UltraTerm Addendum
Modification to allow the UltraTerm to operate
with the new enhanced Apple //e

March 12, 1985
ULT-DOC-000

Figure 1 : Position of diode jumper block and connector on the UltraTerm.

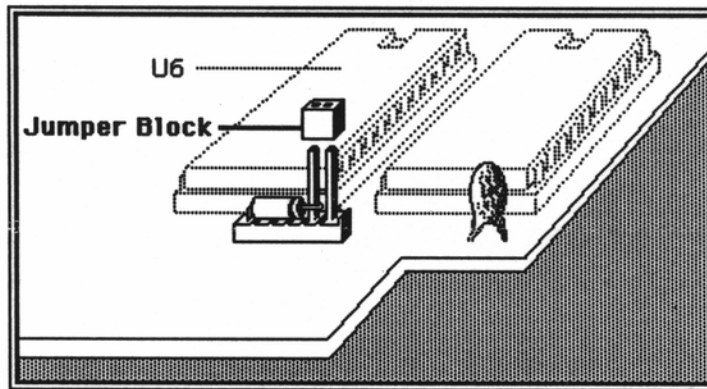
The UltraTerm has been modified in order to accommodate both versions of Apple //e. This modification adds a jumper connector below U6 on the UltraTerm [please see figure 1].

- If the UltraTerm is to be used in an older Apple //e then the jumper block should be placed across the two upright pins of it's connector and the J1 jumper block should be across the **upper** pins of it's connector.

- If the UltraTerm is to be used in an Apple II, II+, or an enhanced Apple //e then the jumper block should be removed from it's connector and the J1 jumper block should be across the **lower** pins of it's connector.
